Model	F401 Sorter Stapler	Volt/Hz	Date of Modification	Serial Number
Modified Article	Parts Catalog			
Reason for Modification	Parts catalog correction

Model: F401 Sorter Stapler		Date: 15-Feb-98	No: 2
Modified Article: Gripper Solenoid Bracket etc		Prepared by: F.Noguchi	
From: QAC Field Information Dept.			
Reason for Modification:	☐ Parts catalog correction ☐ Vendor change ☐ To meet standards ☐ To facilitate assembly ☐ To improve reliability () ☒ Part standardization ☐ Other

Model: Sorter Stapler for F401S		Date: 31-Jul-98	No: 3
Modified Article: Front Cover Plate		Prepared by: F.Noguchi	
From: QAC Field Information Dept.			
Reason for Modification:	☐ Parts catalog correction ☐ Vendor change ☐ To meet standards ☒ To facilitate assembly ☐ To improve reliability () ☐ Part standardization ☐ Other

Page 18

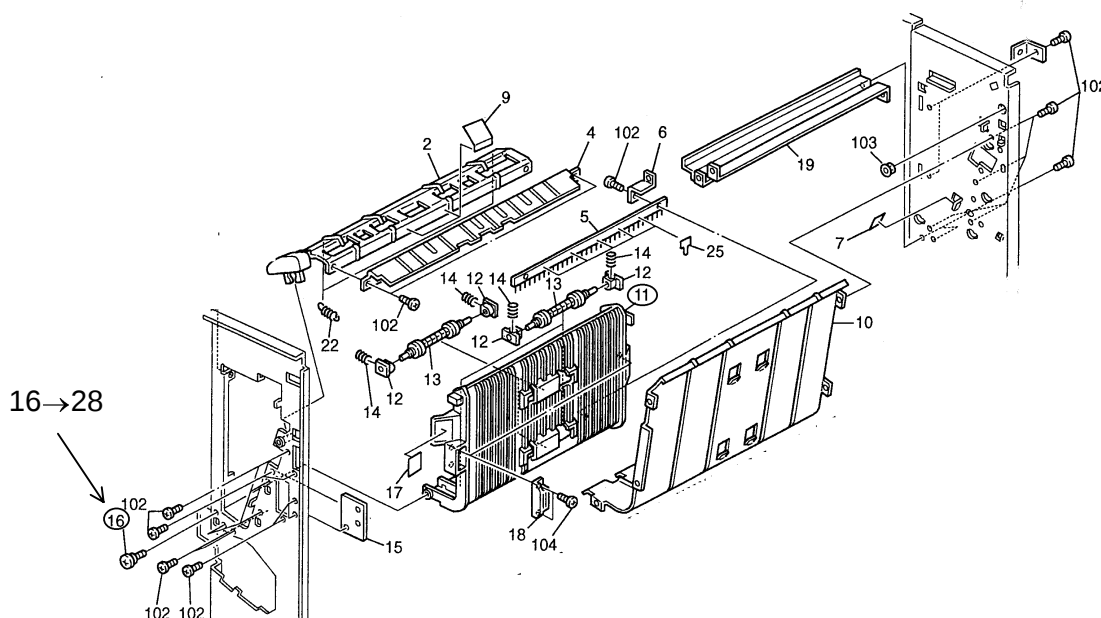
Old part number	New part number	Description	Qty	Int	Page	Index	Note
A6644721	A8214721	Stapler Slide Bracket	1	O/O	9	16	
A3771636	A8211636	Upper Rear Cover Bracket	1	O/O	11	27	
A3772141	A8212141	Left Lower Guide	1	X/X	19	11	*
54131882		Stepped Screw	3-2	X/	19	16	
	A8212151	Stopper-Guide Plate-Left Lower	0-1	/X	19	*28	*
A6641171	A8211171	Exit Tray	1	O/O	19	19

*Note: Due to a change in the mold of the Left Lower Guide (A3772141), the old one can no longer be supplied. When installing the new Left Lower Guide (A8212141), please use the Stopper -Guide Plate - Left Lower (A8212151).

Page 19

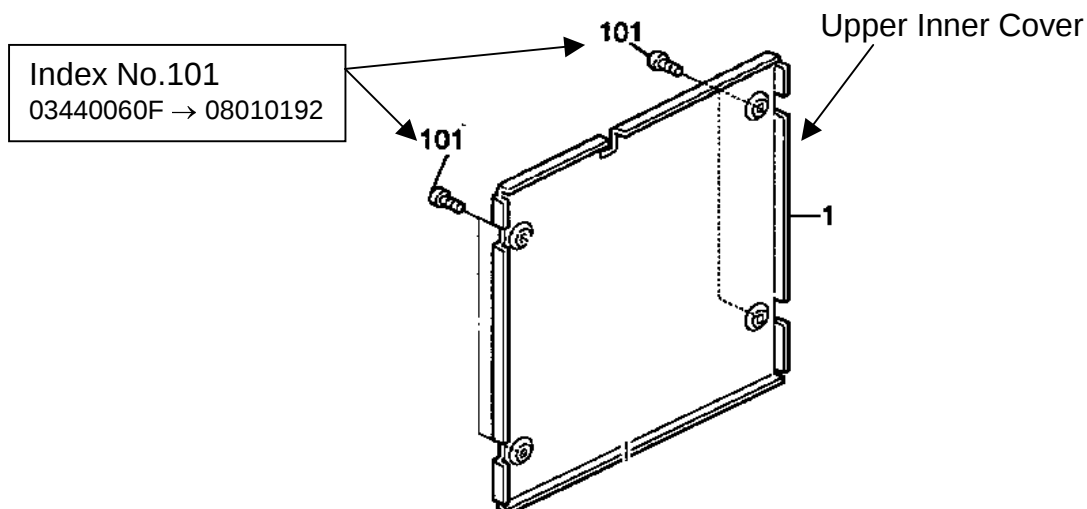
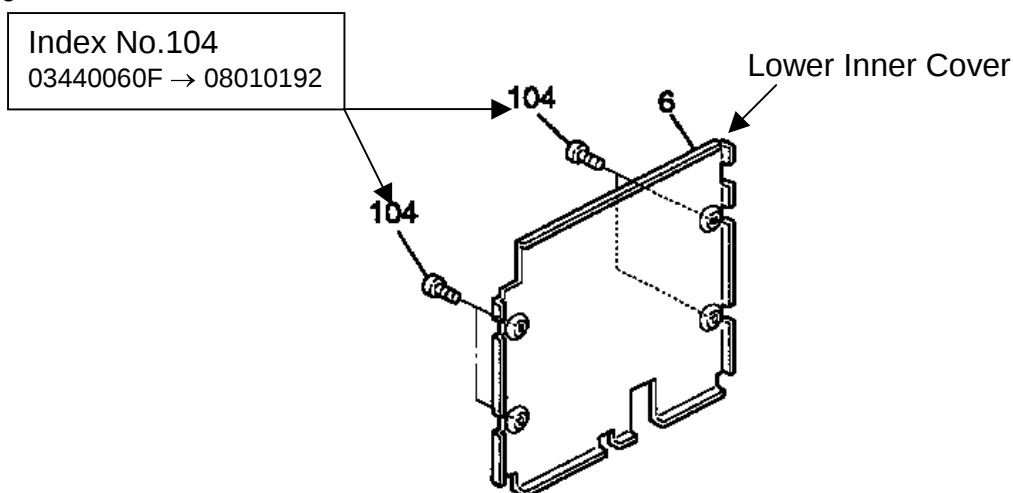
When clearing a misfeed, it is not uncommon for the cover screws to scratch the back of the hand. To prevent this, the shape of the tip of the screw has been rounded off.

Old part number	New part number	Description	Q'ty	Int	Page	Index	Note
03440060F		Philips Truss Head Screw – M4x6	n - n	X/O	19	101	
	08010192	Bind Screw – M4x8			21	104
